SEAS DEADLINE 6 RESPONSE to APPLICANTS's SUBMISSIONS
SINCE DEADLINE 5, ISH3, Action Points and ExQ3
LANDSCAPE & VISUAL and CULTURAL HERITAGE

PINS Ref: EN020026
DEADLINE 6: APRIL 13, 2026

EN020026 SEA LINK DCO – DL6: RESPONSE BY NICHOLAS BRIDGES

ZTV ANALYSIS – IP ref FA62B0DA

Figure 8. Sea Link 2023-10 PEIR Volume 3 Part 2 Chapter 2 Figures A, page 10:
 REPRESENTATIVE VIEWPOINT LOCATIONS AND SCREENED ZONE OF THEORETICAL VISIBILITY - PROPOSED PROJECT WITH CO-LOCATION CONVERTER STATIONS AND SPR FRISTON SUBSTATION (OPTION 3)

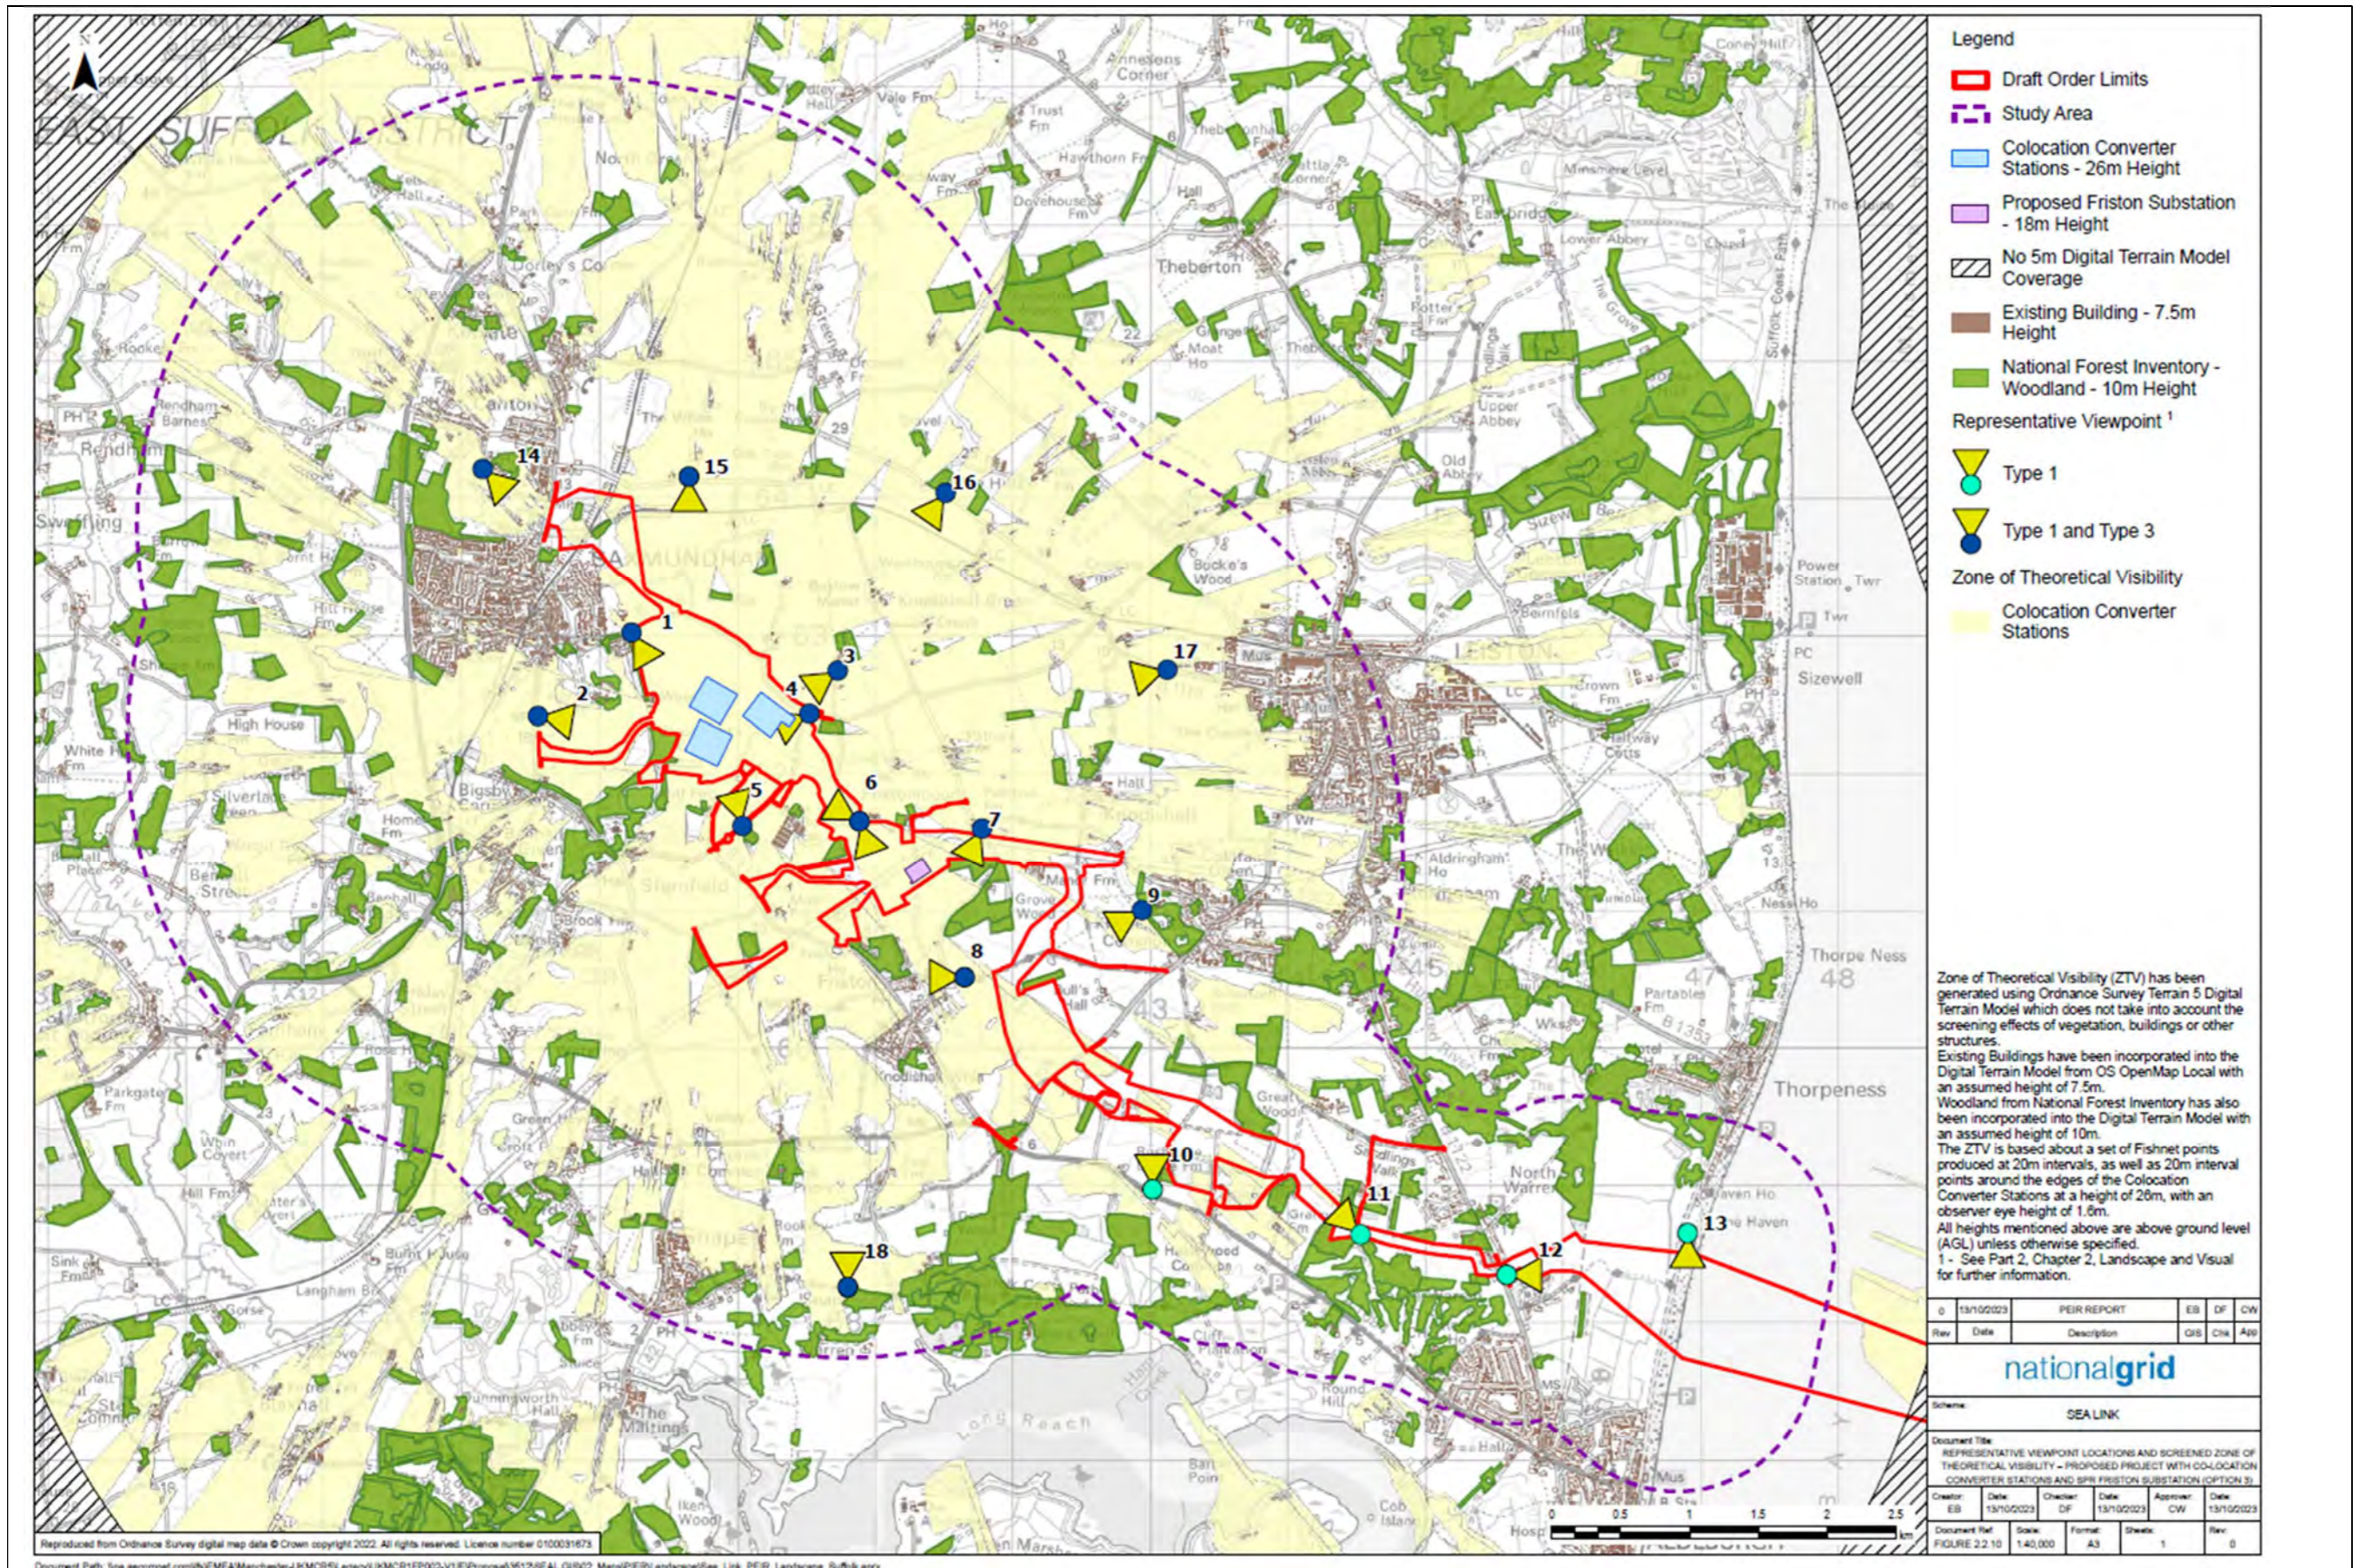
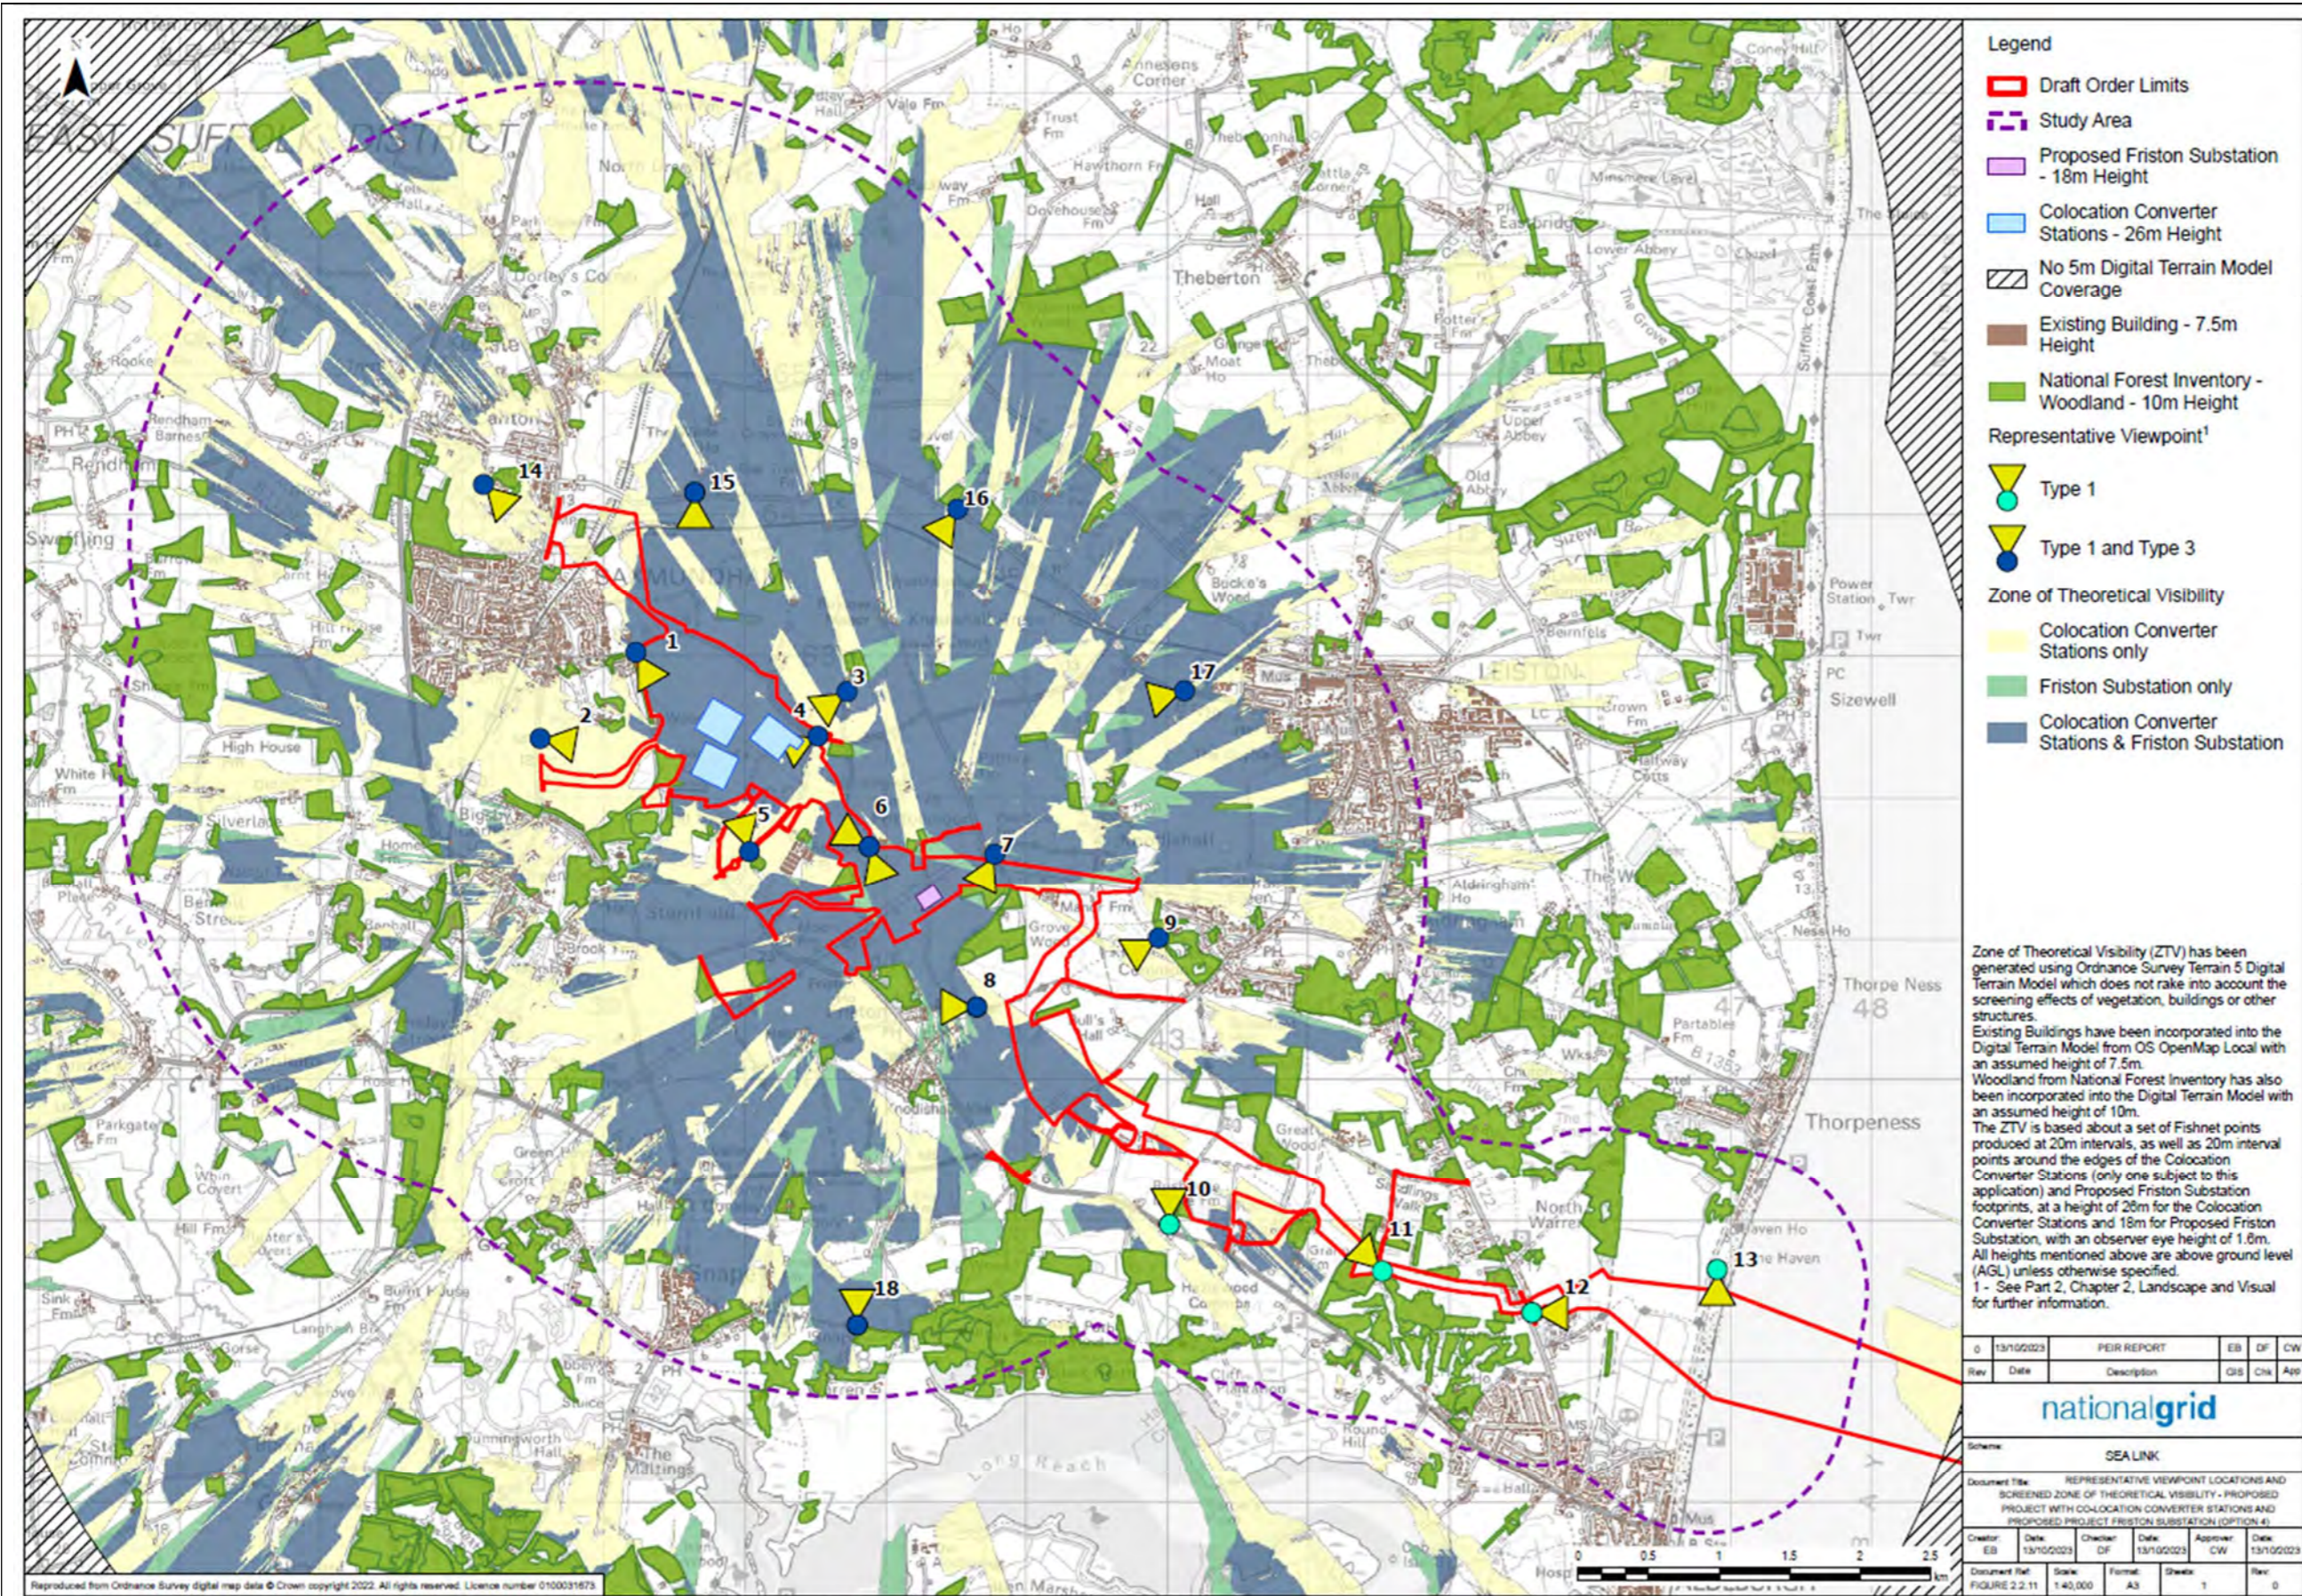
2.9. The ZTVs of the two Friston projects and Sea Link's PEIR have a similar pattern of visibility around their projects (see **Figures 1 to 11** below). Sea Link includes the National Grid substation at Friston which each of EA1N and EA2 also included. All Projects were modelled using OS contours, woodland and buildings at a generic height. Observer heights were a little higher for EA1N and EA2. The two Friston substations used the same parameter model as Sea Link.

2.11. The **first question** is: why are the PEIR and DCO plans so completely different? Were the heights in the model changed? Were the shadowing criteria altered? Which is correct? If the DCO is correct, were the EA1N and EA2 ZTVs incorrect? These are simple technical points which can be explained easily.

2.19. The Sea Link ES LVIA decided not to extend the coverage of its ZTVs when its PEIR had already revealed visibility of the
